North Eastern Regional Power Committee

Sub: 83वीं संरक्षण समन्वय उप-समिति (पीसीसी) बैठक का कार्यवृत्त/ Minutes of 83rd Protection Coordination Sub-Committee (PCC) Meeting

83rd Protection Coordination Sub-Committee Meeting

Date: 18/09/2025 (Thursday)

C.5 (Agenda B10, 81st PCC) Grid Disturbance in Ningthoukhong area of Manipur Power System on 9th June'25:

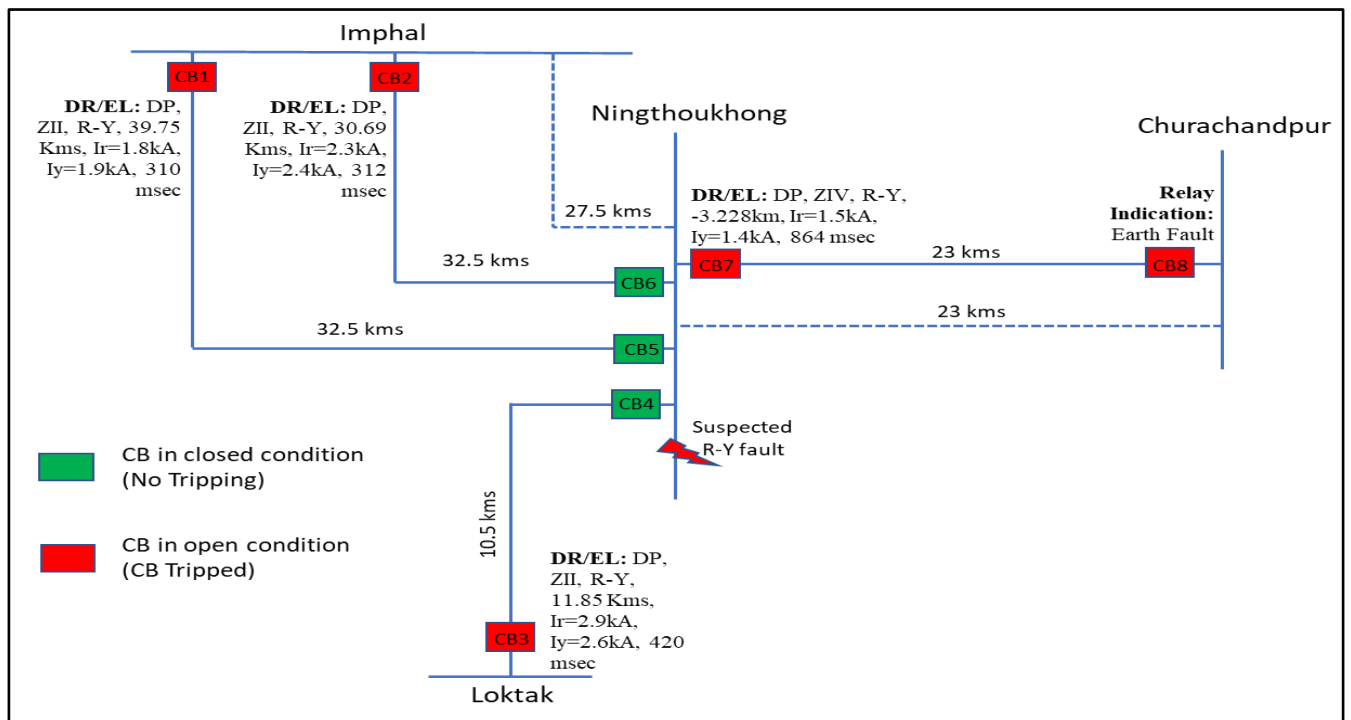
At 13:34 Hrs of 09-06-2025, 132 kV Imphal-Ningthoukhong ckt 2, 132 kV Imphal-Ningthoukhong ckt 3, 132 kV Loktak-Ningthoukhong, 132 kV Ningthoukhong-Churachandpur 2 tripped. Due to tripping of these elements, Ningthoukhong area of Manipur Power System got isolated from NER Grid and collapsed due to no source available in this area. Load loss of 9 MW occurred.

MSPCL to share the root cause of the event and provide update on the above-mentioned issues.

C.6 (Agenda B11, 81st PCC) Grid Disturbance in Dharmanagar area of Tripura Power System and Dullavchera area of Assam Power System on 10th June'25:

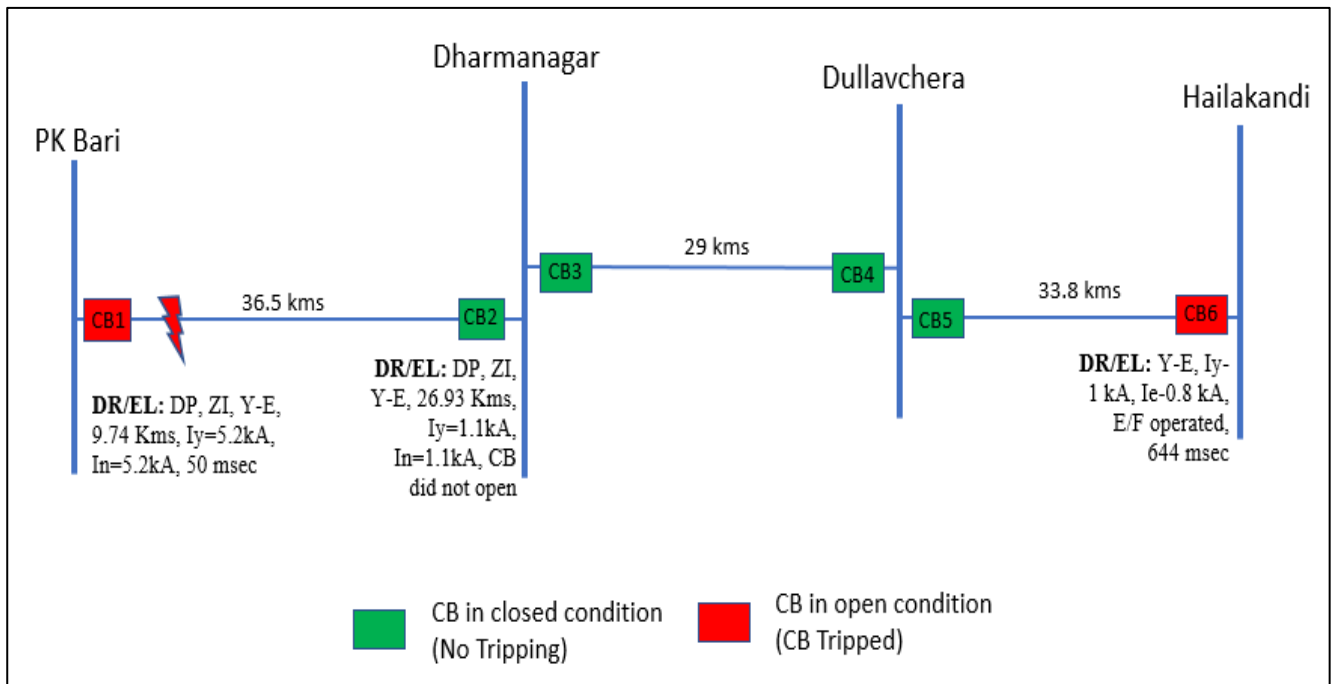
At 18:45 Hrs of 10-06-2025, 132 kV Dharmanagar-PK Bari line & 132 kV Hailakandi-DULLavchhera line tripped resulting in grid disturbance in Dharmanagar & Dullavchhera areas. Load loss of 35 MW occurred.

As per DR analysis, Y-N fault ($I_b=5.2\text{ kA}$, $I_n=5.2\text{ kA}$) initiated at 18:40:57.118 Hrs which was cleared within 50 msec from PK Bari on operation of DP, ZI. At Dharmanagar end, ZI trip command issued at 18:25:30.360 Hrs. However, CB did not open at Dharmanagar due to which fault was continuously feeding from Dullavchhera & Hailakandi end. Fault cleared by tripping of healthy 132 kV Hailakandi-Dullavchhera line within 644 msec from Hailakandi end on operation of E/F (DT send).

Event 1:

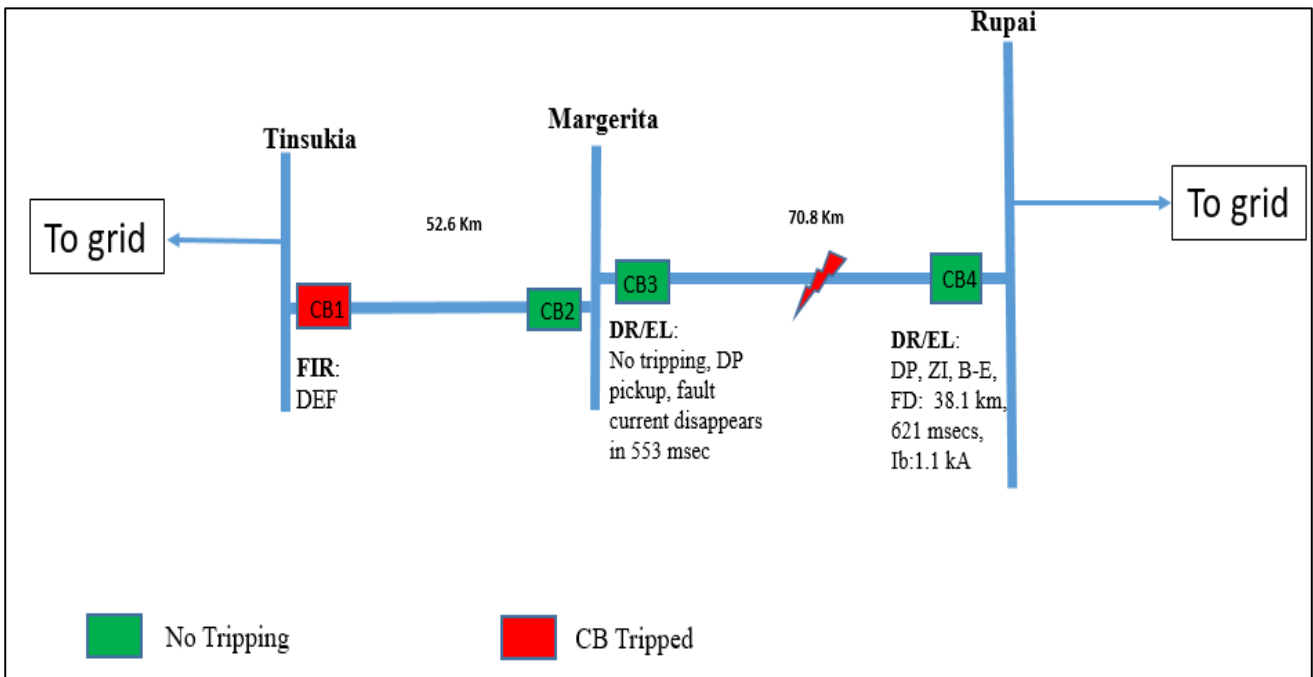
At 10:53 Hrs of 17-06-2025, 132 kV Tinsukia – Margherita & 132 kV Rupai-Margherita line tripped leading to blackout of Margherita area of Assam. Load loss of 21 MW occurred.

As per DR analysis, at 10:50:26.946 Hrs, high resistive B-E fault (Ib-1.1 kA, Vbe-51 kV) appears in 132 kV Rupai-Margherita line at a distance of 38.1 Km which was cleared from Rupai end within 621 msec on operation of DP, ZI. No tripping observed at Margherita end (DP pickup, fault current disappears within 553 msec). Fault cleared from Tinsukia end on operation of DEF (as per FIR, DR/EL not submitted)

- Protection system at Margherita end for 132 kV Rupai Line failed to isolate the fault leading to clearing of fault by tripping of healthy 132 kV Margherita-Tinsukia line from remote end.
- Time drift of 3 min observed at Rupai end for 132 kV Margherita Line.

Event 2:

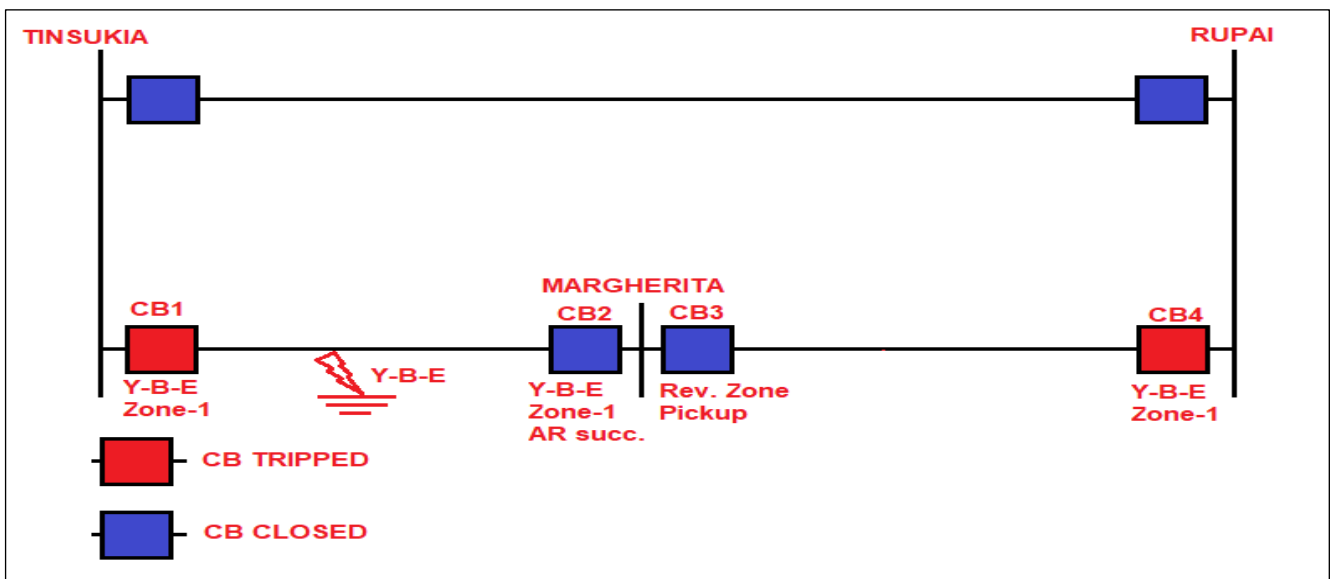
At 22:59 Hrs of 22-06-2025, 132 kV Tinsukia – Margherita & 132 kV Rupai-Margherita line tripped leading to blackout of Margherita area of Assam. Load loss of 4 MW occurred.

As per DR analysis, Y-B-E fault in 132 kV Tinsukia – Margherita line cleared from Tinsukia and Margherita end in 90 msecs on operation of DP, ZI. Margherita end (CB2) successfully auto-reclosed.

Event 2: Forum noted that zone 1 at Rupai for 132 kV Margherita line is overreaching and requested AEGCL to revise the reach of Zone1 protection. AEGCL informed S/D will be taken for testing of relay.

C.9 (Agenda B15, 81st PCC) Grid Disturbance in Leshka, Mynkre, Mustem and IIM areas of Meghalaya Power System on 19th June'25:

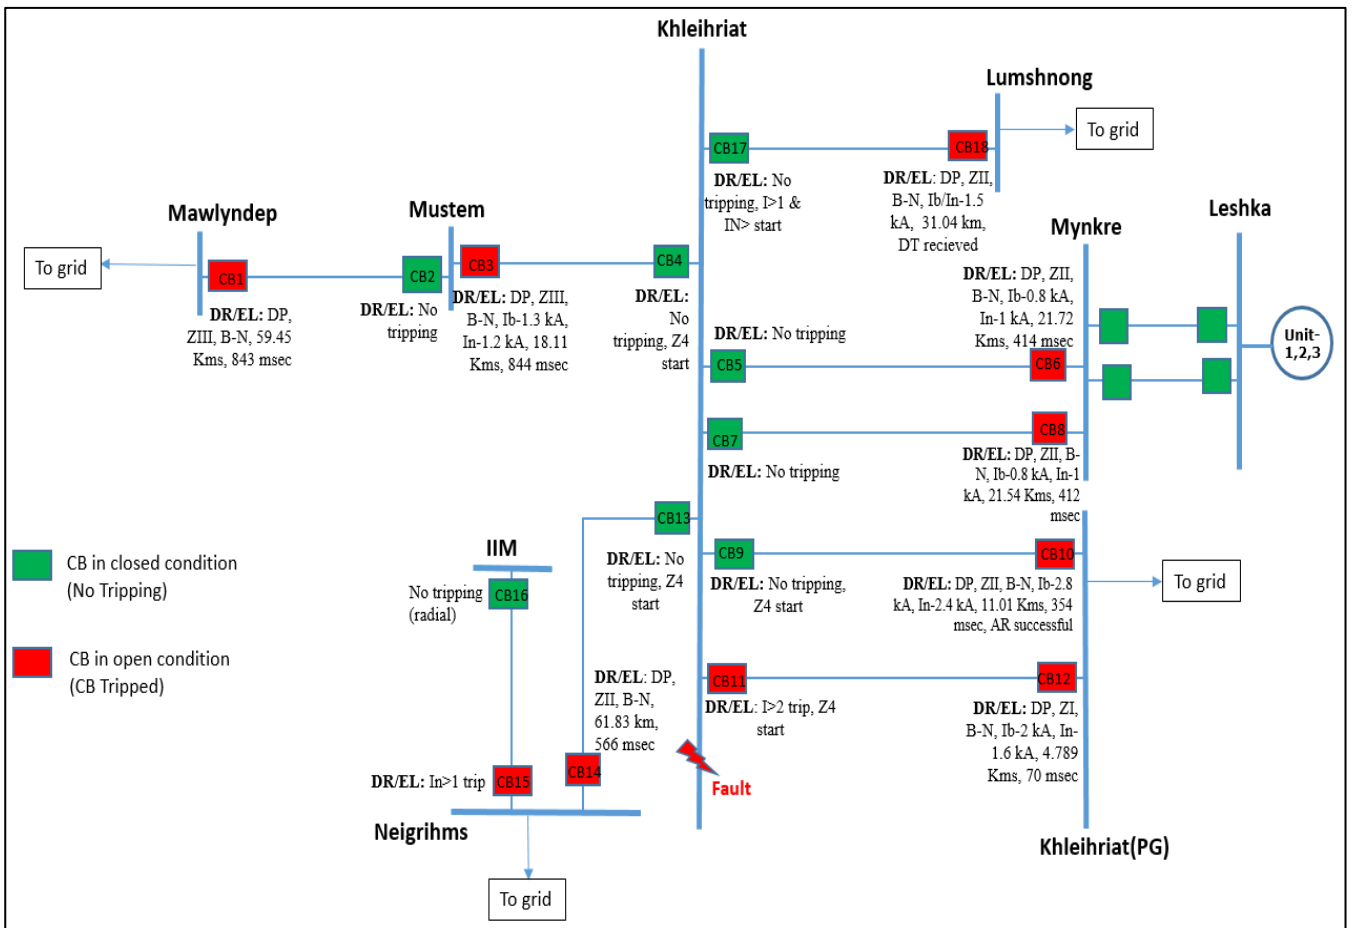
At 14:00 Hrs of 19-06-2025, all the lines connected to 132 kV Khleihriat Bus except 132 kV Khleihriat-Khleihriat (PG) I line, 132 kV Mawlyndep-Mustem & 132 kV Neigrihms-IIM lines tripped. Due to these tripping, Leshka, Mynkre, Mustem and IIM areas of Meghalaya Power System got isolated from NER Grid and collapsed due to no source available in these areas.

- Tripping of 132 kV Mustem-Khleihriat line on Z3 from Mustem end is inferred unwanted. Z3 reach setting needs to be reviewed and revised as per NER protection philosophy.

line tripped on I>2 from Khl(ME) end	Khl(ME)
3	AR operated successfully at Khleihriat(PG) end for 132 kV Khleihriat-Khleihriat(PG) I Line	AR successful due to incorrect mapping which has been rectified.
4	Tripping of 132 kV Mustem-Khleihriat line on Z3 from Mustem end	LFL of the feeder was carried out to ascertain the exact line length and line length indicated was 16.9 Km. Earlier setting was kept as per 12.69 Km. The setting of 132 kV Mustem-Khleihriat line has been revised as per new line length of 16.9 Km on 25th June'25.
5	DT received at Lumshnong end for 132 kV Khleihriat Line	To be checked by MePTCL
6	Tripping of 132 kV Neigrihms-IIM line on E/F from Neigrihms end for fault in reverse direction is unwanted	Rectified
7	Tripping of Umiam Stg-II Unit-2 for fault in 132 kV Khleihriat Bus	GT O/C protection operated. To be checked by MePGCL
8	Time drift of 9 min observed at Mynkre end for Khleihriat line - 1&2 lines	GPS rectified on 16th July'25

Regarding the Bus Bar protection at Khliehriat SS, Forum advised MePTCL to expedite the matter at higher level.

C.10 (Agenda B16, 81st PCC) Multiple tripping in Ningthoukhong S/S of Manipur power system on 20th June'25:

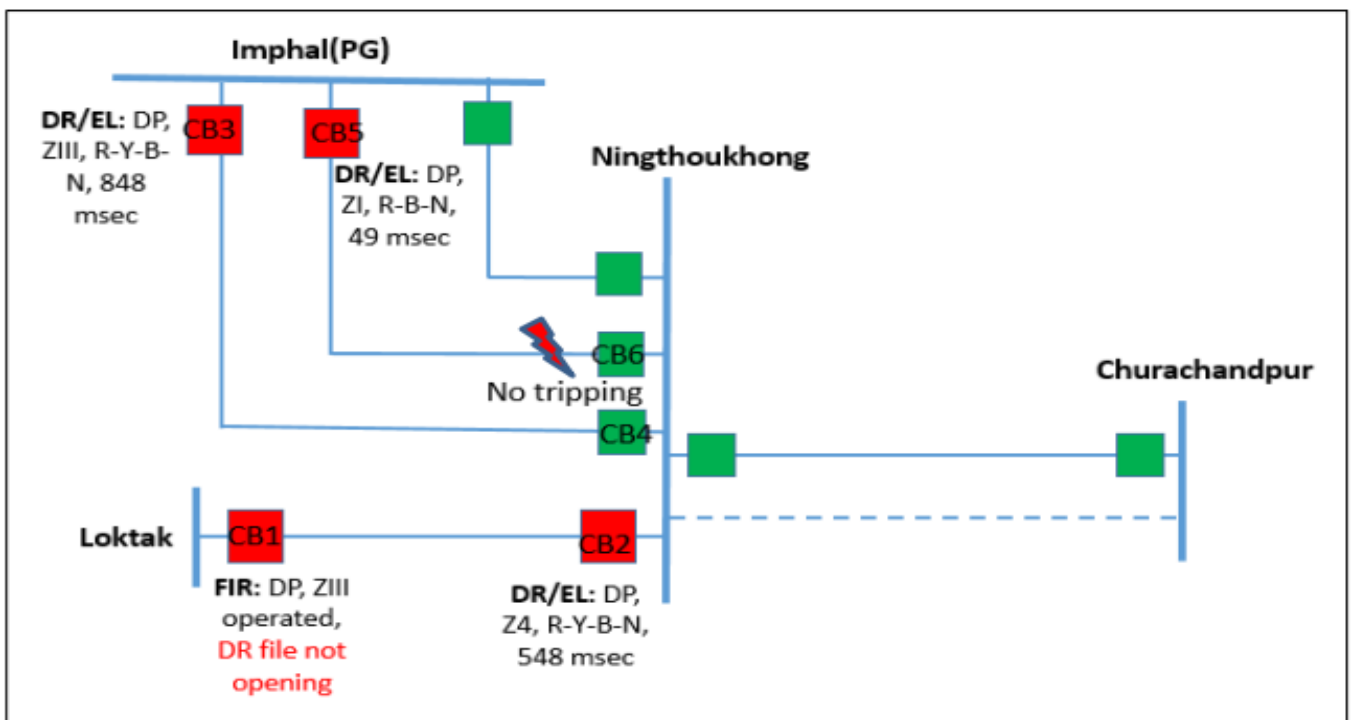
At 03:52 Hrs of 20-06-2025, 132 kV Imphal-Ningthoukhong I, 132 kV Imphal-Ningthoukhong II & 132 kV Loktak-Ningthoukhong lines tripped.

As per DR analysis, solid R-B-N fault (Ir-2.4 kA, Ib-0.8 kA, In-1.7 kA) initiated at 03:52:00.925 Hrs which was cleared within 49 msec from Imphal(PG) end on operation of DP, ZI. There was no tripping from Ningthoukhong due to which fault was continuously feeding from other lines at Ningthoukhong.
